THE CORPORATION OF THE CITY OF NIAGARA FALLS

ADDENDUM #3

RFT12-2021

City of Niagara Falls Municipal Service Centre Renovation

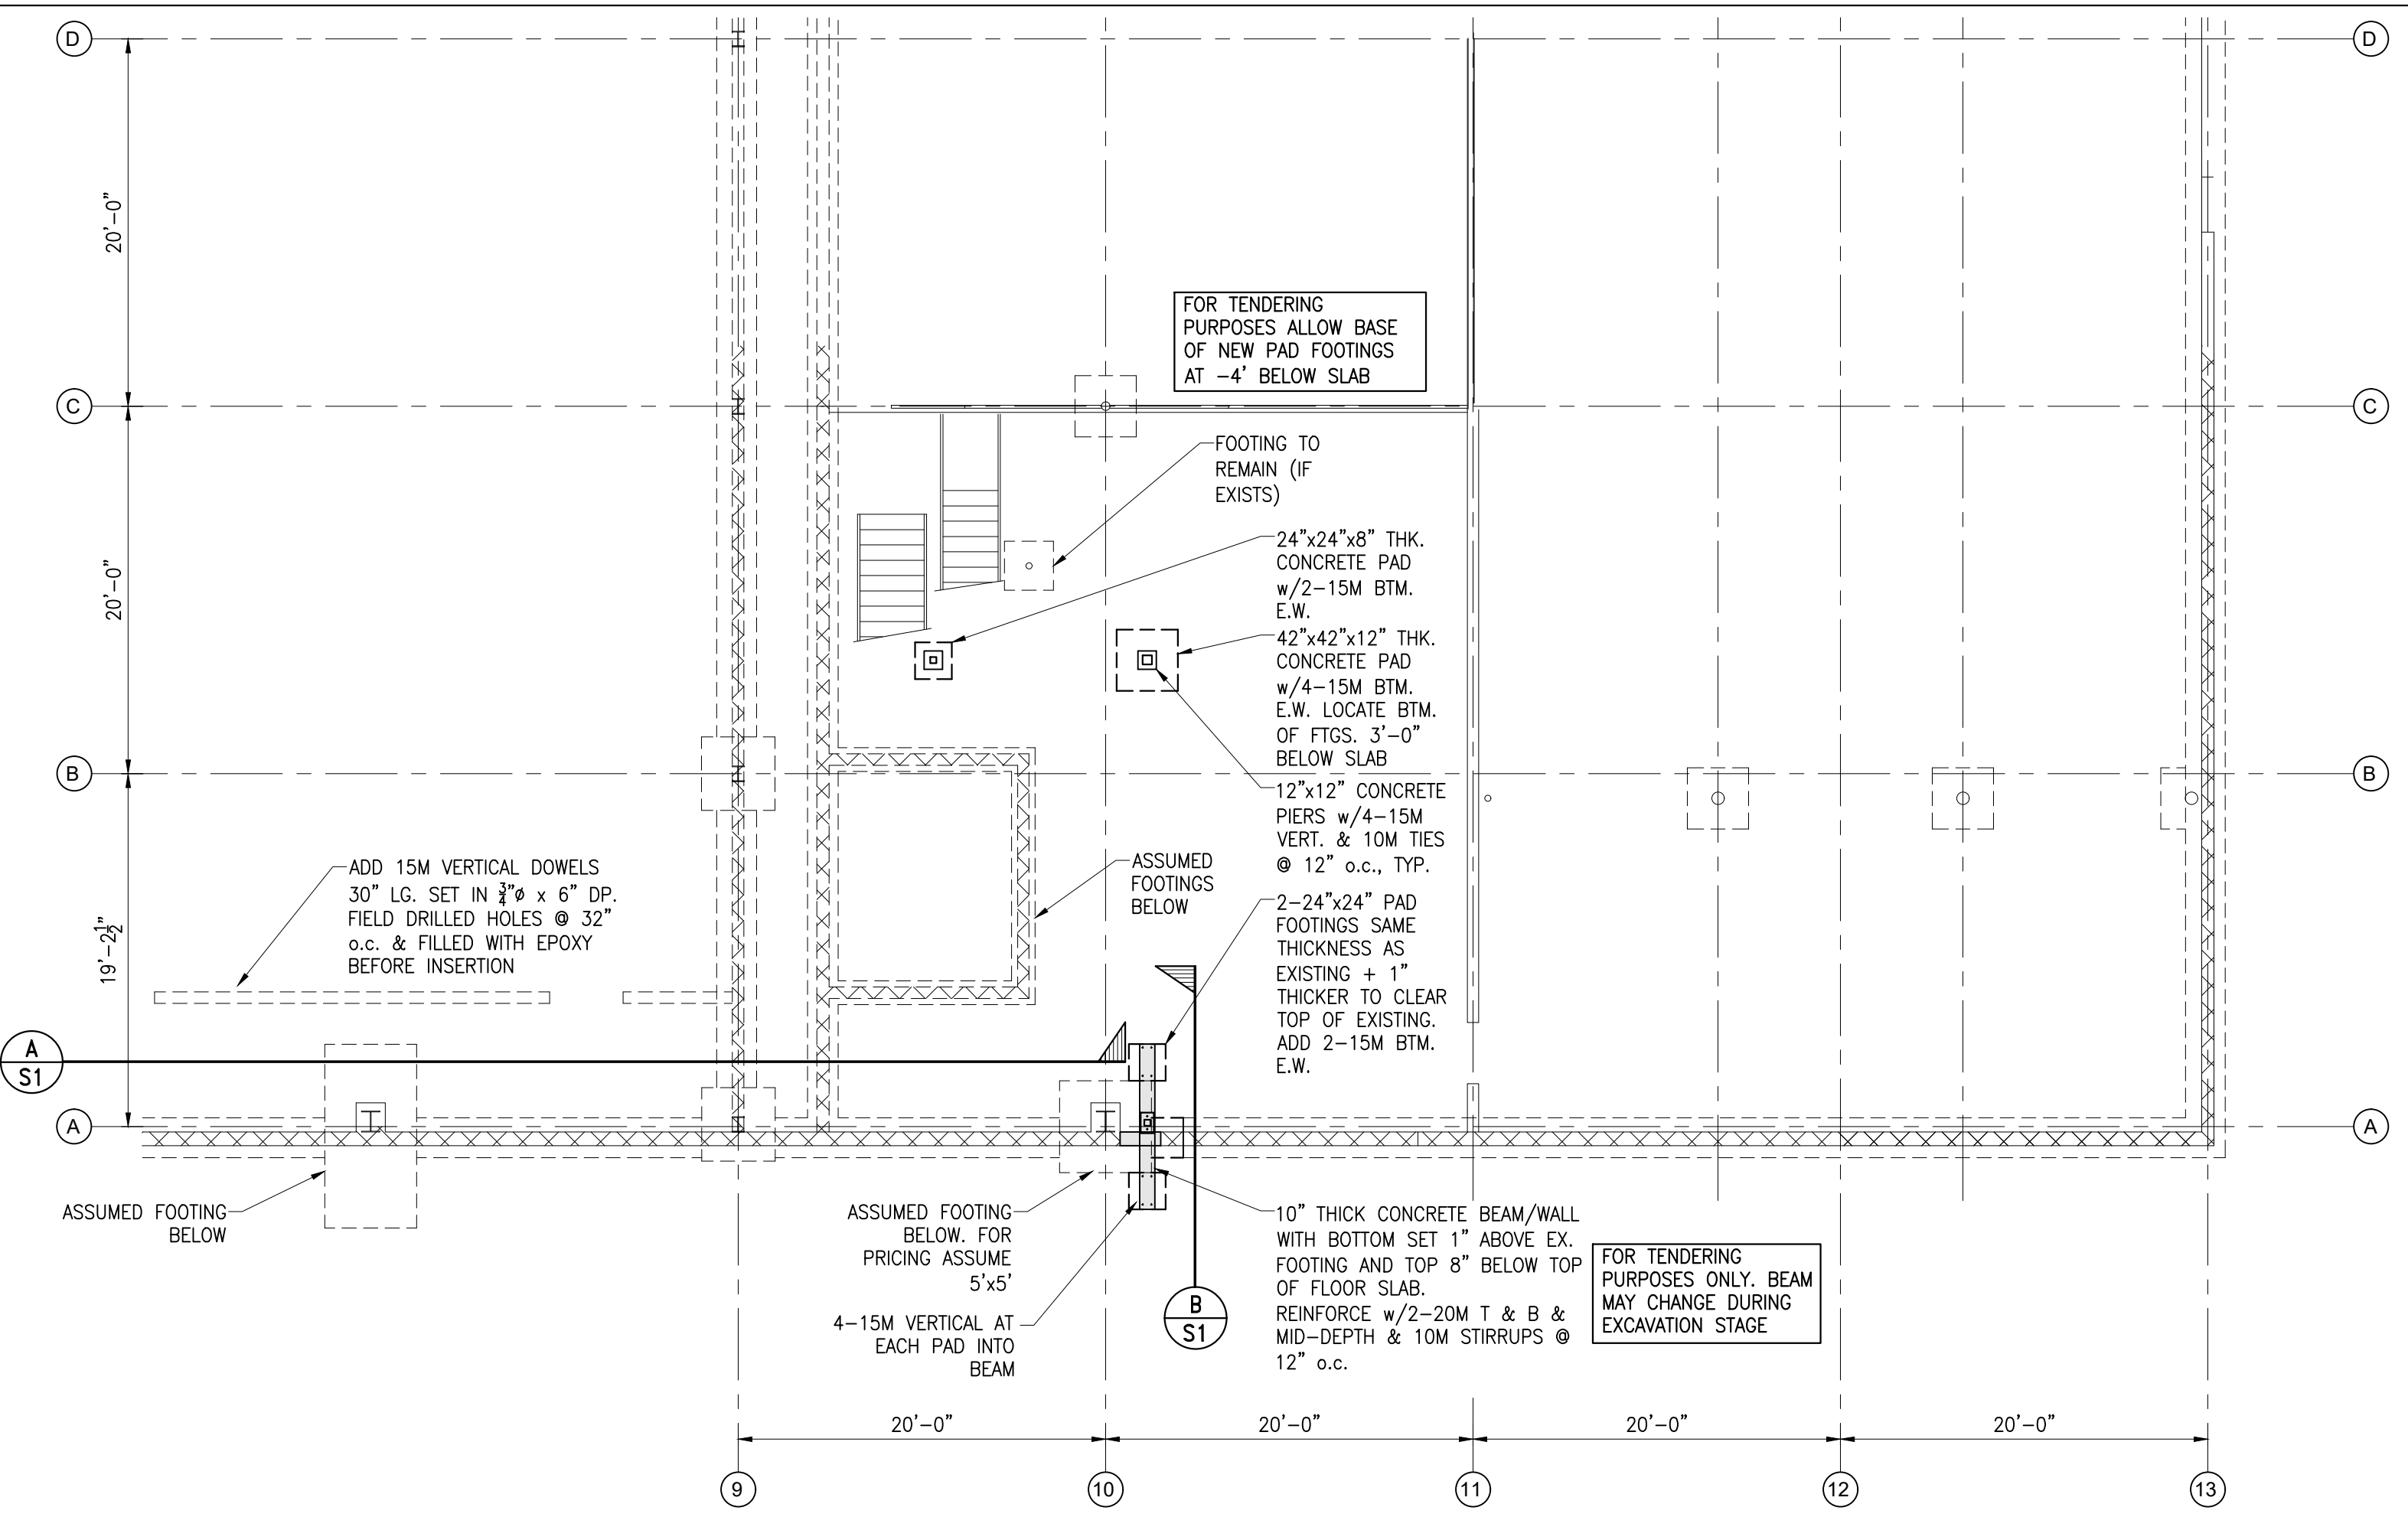
Q2. Please be aware that the new HSS steel column (HSS3x3x0.188) on gridlines Bx-9x as well as the knee braces supporting the beams are too small to be coated in intumescent. Another method of fireproofing may be required unless the steel size is increased.

A2. The new HSS 3x3x0.188 column at gridlines Bx-9x is currently inside an ULC w453 - 1 hour fire rated partition "P03", therefore intumescent paint is not required at this column.

Any exposed steel plate/connections outside of the fire rated partition to receive intumescent paint.
